To: Plan Holders for Improvements to the
St. George Regional Airport
St. George, Utah
AIP Project No. 3-49-0060-045-2023

**ADDENDUM NO. 1
TO
CONTRACT DOCUMENTS, SPECIFICATIONS AND PLANS
FOR IMPROVEMENTS TO THE
ST. GEORGE REGIONAL AIRPORT
ST. GEORGE, UTAH
AIP PROJECT NO. 3-49-0060-045-2023**

RECONSTRUCT AND EXPAND
TERMINAL APRON

DEMOLITION PLAN

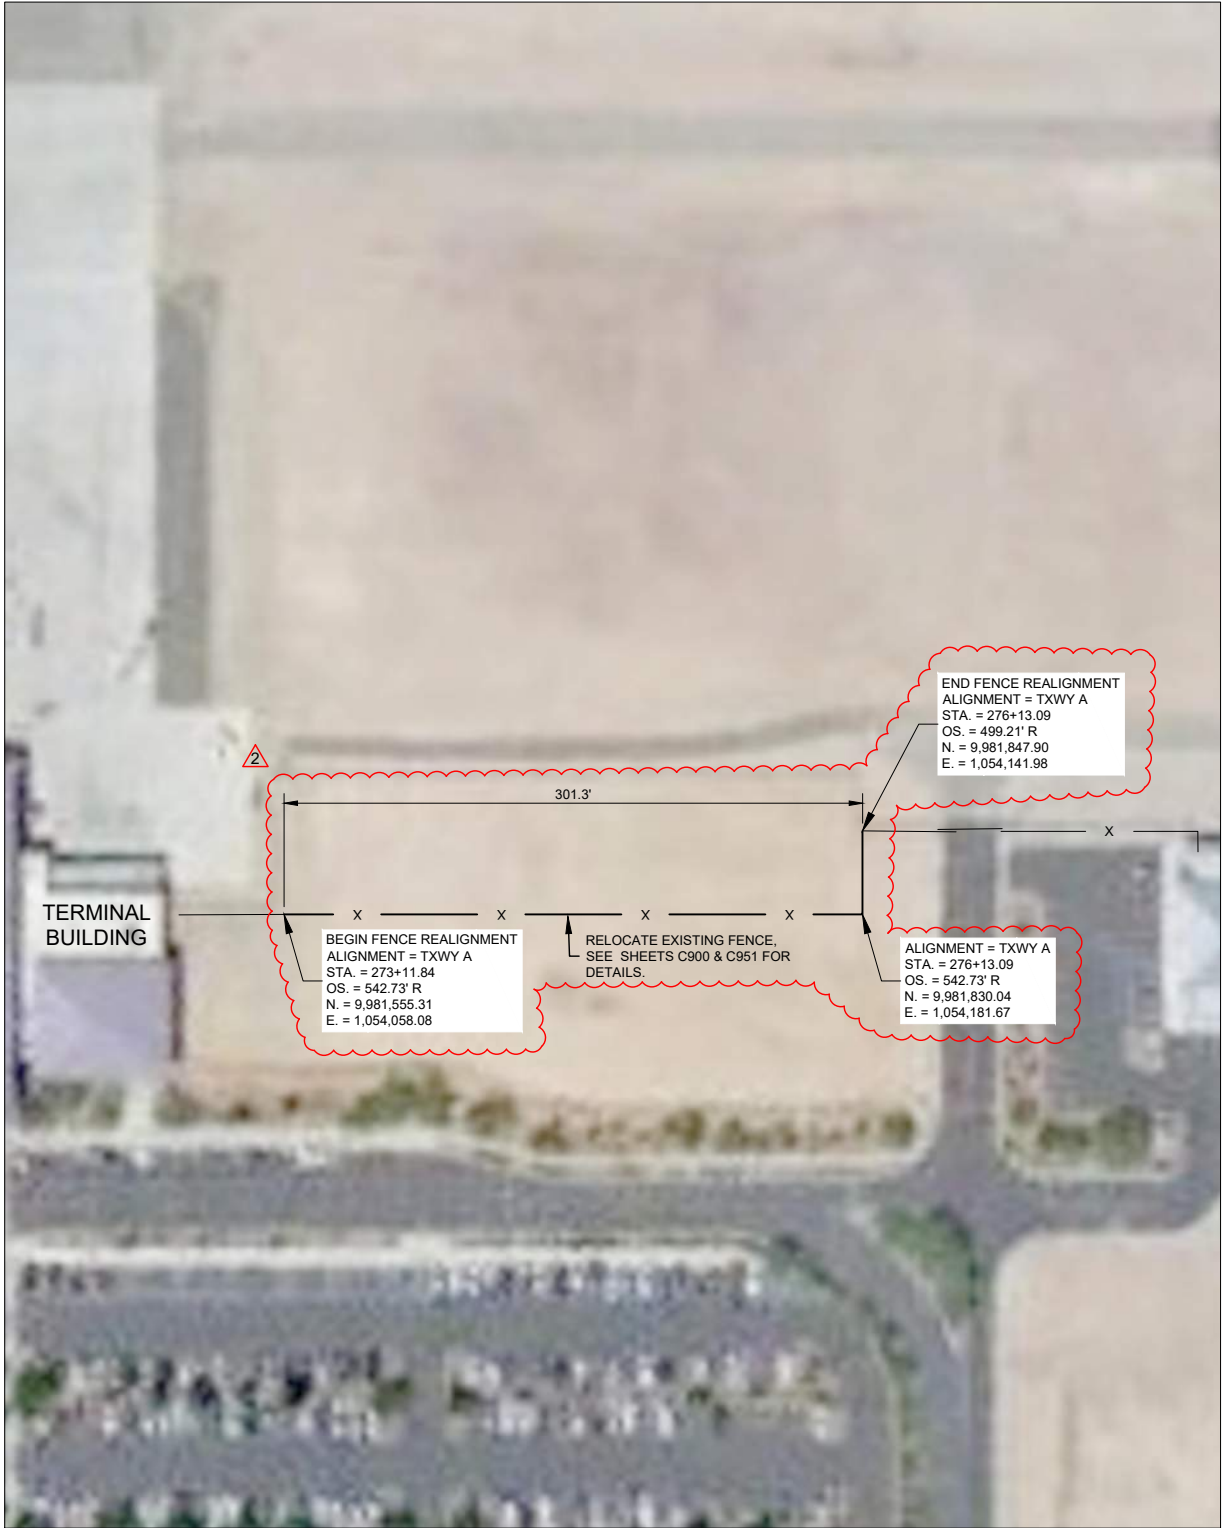
Sheet C100, Demolition Plan:

Replace Sheet C100 with the attached C100, Demolition Plan.

- Replace Sheet C100, Demolition Plan, to: 1) indicate there is an existing geomembrane liner under the south 80 feet of the Terminal Apron to be removed and disposed of as part of the excavation, 2) revise fence removal location, and 3) add note instructing temporary removal and re-installation of the jet bridge as part of the Phase 2 work.
- Replace Sheet C100, Fencing Plan, to change the location of the fence.
- Lighting control clarifications for the Apron Area Lights.
